MWO 9-2350-267-20-4

MODIFICATION WORK ORDER

MODIFICATION OF M992 FIELD ARTILLERY AMMUNITION SUPPORT VEHICLE (FAASV) AUTOMATIC FIRE EXTINGUISHER SYSTEM (AFES) DECAL KIT

30 June 1992

Figure 1

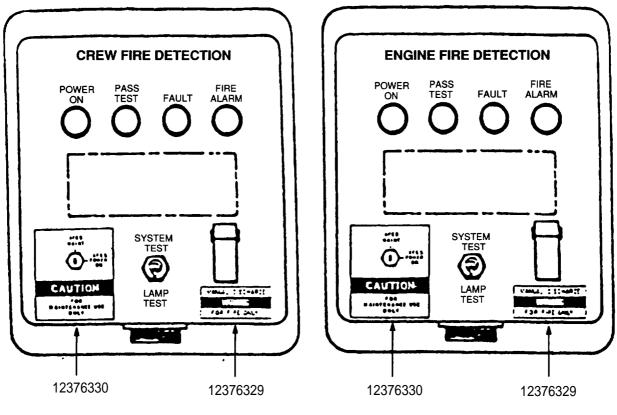
3. Remove the protective backing from labels 12376329* and 12376330*, and position them on the Engine and Crew Test and Alarm Panels as shown in Figure 1.

Figure 2

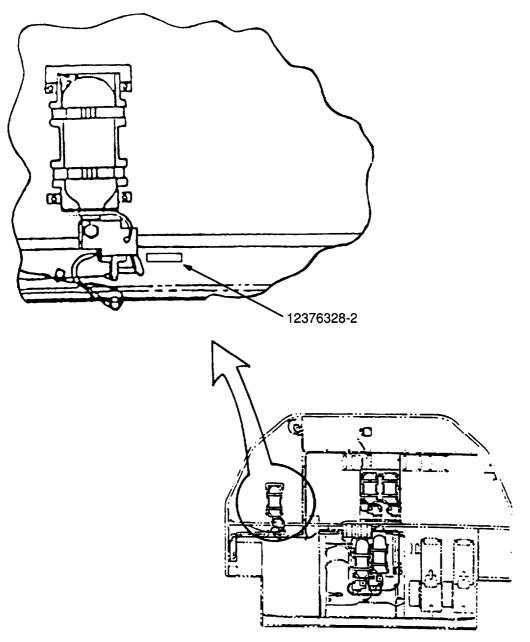
7. Remove the protective backing from label 12376328-2* and position on the APU Bulkhead as shown in Figure 2.

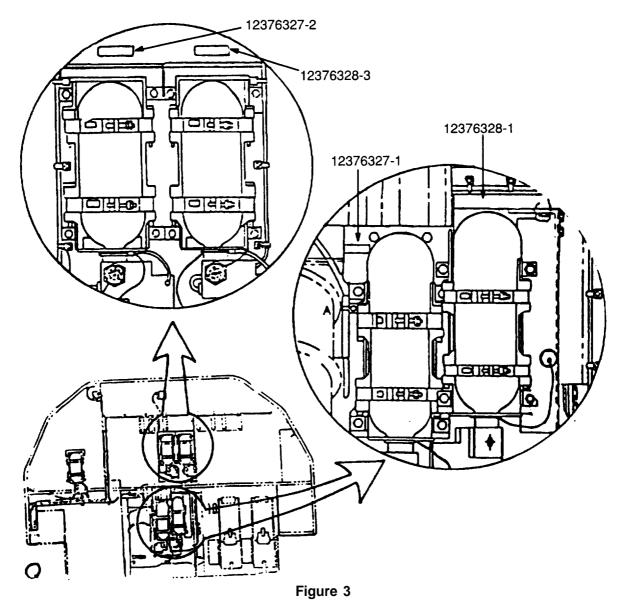
11. Remove the protective backing from appropriate label and position as shown in Figure 3.

Figure 4

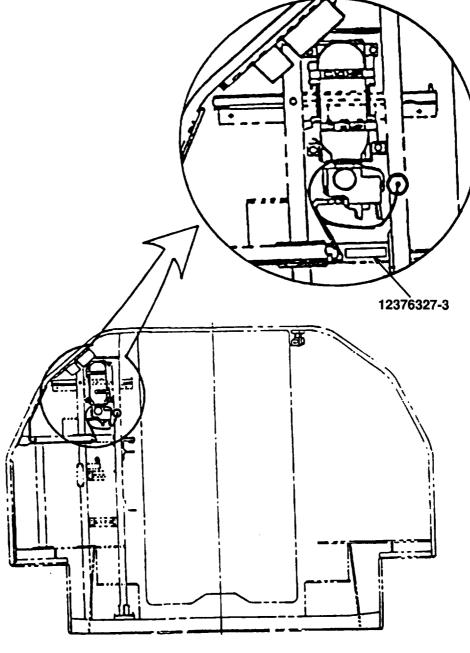
- 14. Clean the surface below the bottle on the rear canister rack with detergent.
- 15. Remove the protective backing from label 12376327-3* and position as shown in Figure 4.

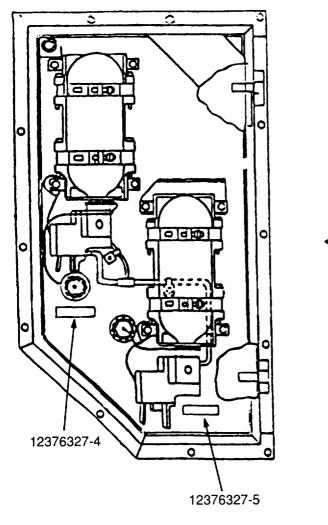
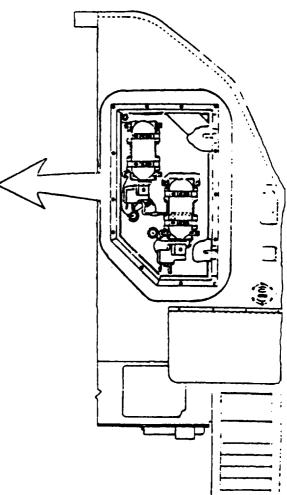
18. Remove the protective backing from labels 12376327-4* and 12376327-5* and position as shown in Figure 5.

Figure 6

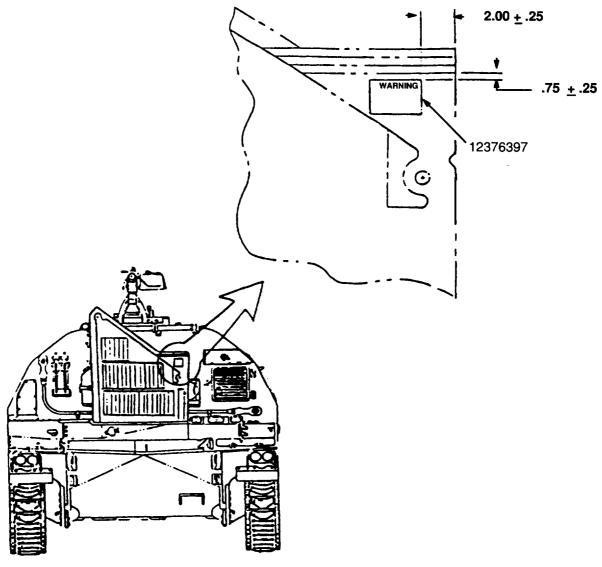
22. Remove the protective backing from label 12376397* and position as shown in Figure 6.

Figure 7

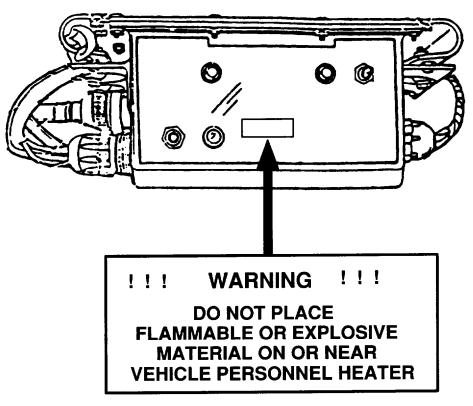
25. Remove the protective backing from label 12268347 * and position on the face of the Accessory Control Box Panel as shown in Figure 7.

Figure 8

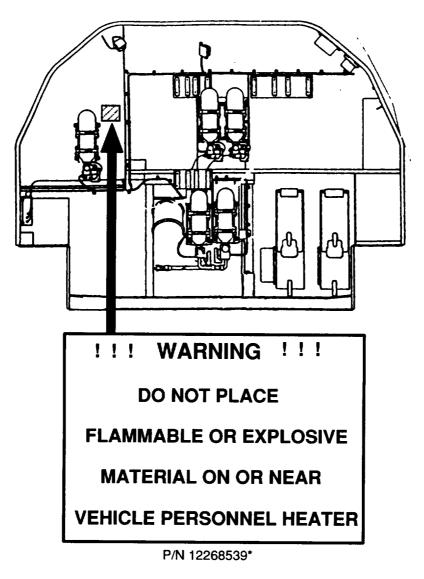
27. Remove protective backing from label * 12268539 and position on APU Bulk Head Wall as shown in Figure 8.
